GREAT OAKS LANDSCAPE BUILDING ADDITION JSP24-07

Consideration at the request of Great Oaks Landscape for Preliminary Site Plan approval and a Section 9 Façade Waiver. The subject property, 28025 Samuel Linden Court, is located north of Twelve Mile Road and west of West Park Drive on a 19.12 acre parcel within the I-2 General Industrial Zoning District. The applicant is proposing to construct a 1,700 square foot addition onto the existing 3000 square foot office building.

PLAN REVIEW CENTER REPORT
Planning Review
GREAT OAKS LANDSCAPE BUILDING ADDITION
 JSP 24-07
 June 10, 2024

SITE PLAN

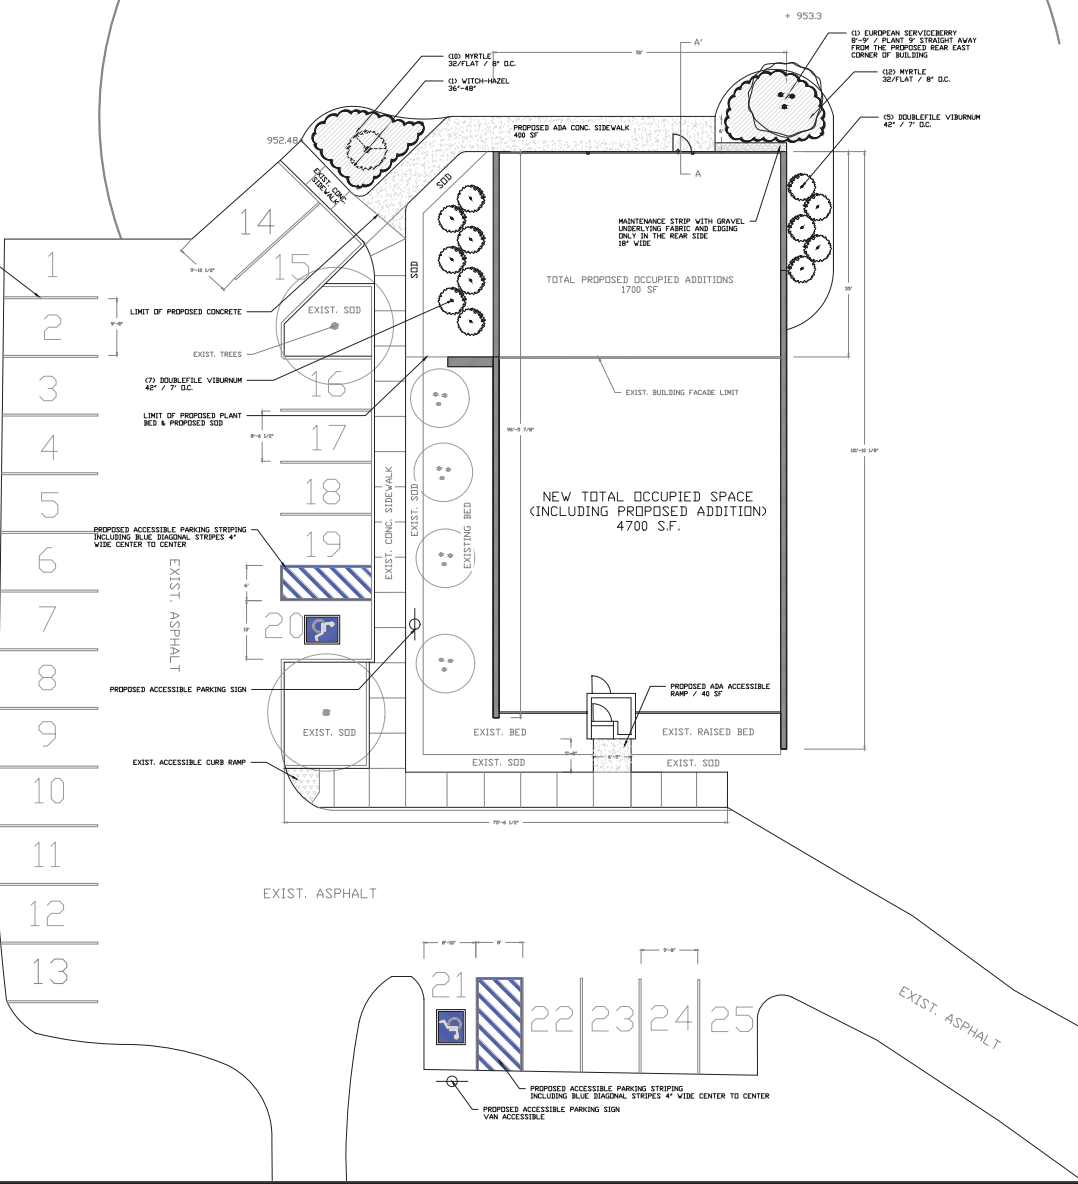
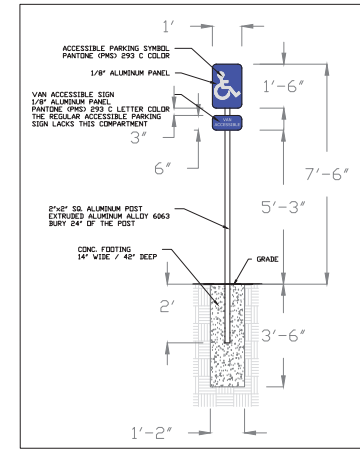
3. Parking Space Dimensions and Maneuvering Lanes (Sec. 5.3.2): Some dimensions are shown but not all. Additionally, some do not meet the required width of 9'. **Please provide the lengths of parking spaces in addition to the width of the drive aisles. See Traffic review letter for more details.**

4. End Islands (Sec. 5.3.12): What appears to be a new end island is shown adjacent to the southern barrier free space. **Please clarify if this end island is being proposed and if so provide its dimensions.**

5. Bicycle Parking (Sec. 5.16): Bicycle parking required due to enlargement of principal building exceeding 10%. One space required – none provided. **Please provide bicycle parking and details.**

Item	Required Code	Proposed	Meets Code	Comments
2019)	4,700 sf/700 sf = 7 spaces required			
Parking Space Dimensions and Maneuvering Lanes (Sec. 5.3.2)	<ul style="list-style-type: none"> - 90° Parking: 9 ft. x 19 ft. - 24 ft. two way drives - 9 ft. x 17 ft. parking spaces allowed along 7 ft. wide interior sidewalks as long as detail indicates a 4" curb at these locations and along landscaping 	Existing spaces being striped. 21 90° parking spaces with 9'8" width and unknown length. Drive aisle width unknown. 2 angled spaces approx. 9'10.5" wide and unknown length	Yes?	<p>Please provide lengths of parking spaces. Please also provide drive aisle width.</p> <p>See Traffic review letter for more detail.</p>
End Islands (Sec. 5.3.12)	<ul style="list-style-type: none"> - End Islands with landscaping and raised curbs are required at the end of all parking bays that abut traffic circulation aisles. - The end islands shall generally be at least 8 ft. wide, have an outside radius of 15 ft., and be constructed 3 ft. shorter than the adjacent parking stall 	No change?	Yes?	<p>Is there a new end island being proposed adjacent to the southern barrier free space? Please dimension if so</p>

- Item #2 - We have received approval from DRN Associates for a section 9 facade waiver for the overage of the standing seam roof.
- Item #3 - The lengths of the parking spaces has been detailed on the site plan.
- Item #4 - There will be no actual island adjacent to the Southwest HC parking space only striping will designate this area.
- Item #5 - We have provided the location of the bicycle rack along the Northwest side of the building addition.

- We have provided a total of 25 parking spaces – 2 for HC and 23 regular spaces.
- All parking spaces have been dimensioned.
- No island will be proposed at the West end of South parking area.
- Bicycle rack is shown on plans.
